NHTSA Recall Number: 21V541

## **IMPORTANT SAFETY RECALL**

**Subject: SMART-STEER 2.0 Bolt-On Steer Arm Reinforcement Welds**

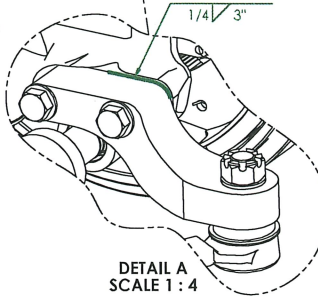
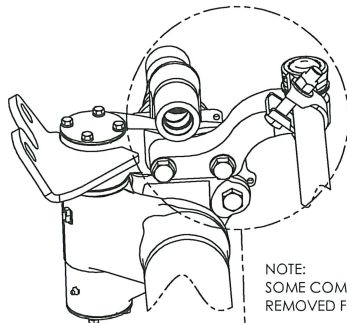
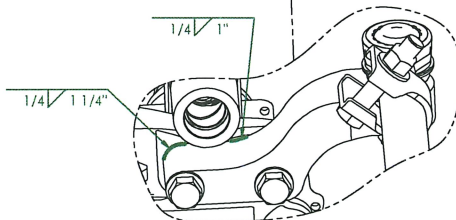
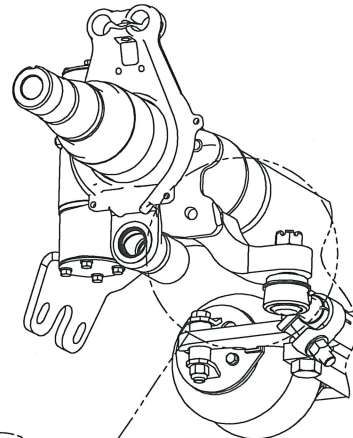
1. Visually inspect steer arm bolts and washers for mechanical tightness and replace if necessary.
2. Ensure the steer arm bolts are torqued to 400 Ft. Lbs.
3. Place welds as shown on page three of this bulletin. If you would like a copy of engineering drawing 750049, please contact one of the service technicians listed below.

NOTE:  
TURN KNUCKLE AT FULL TURN TO  
GAIN ACCESS TO STEER ARM  
AND WELD
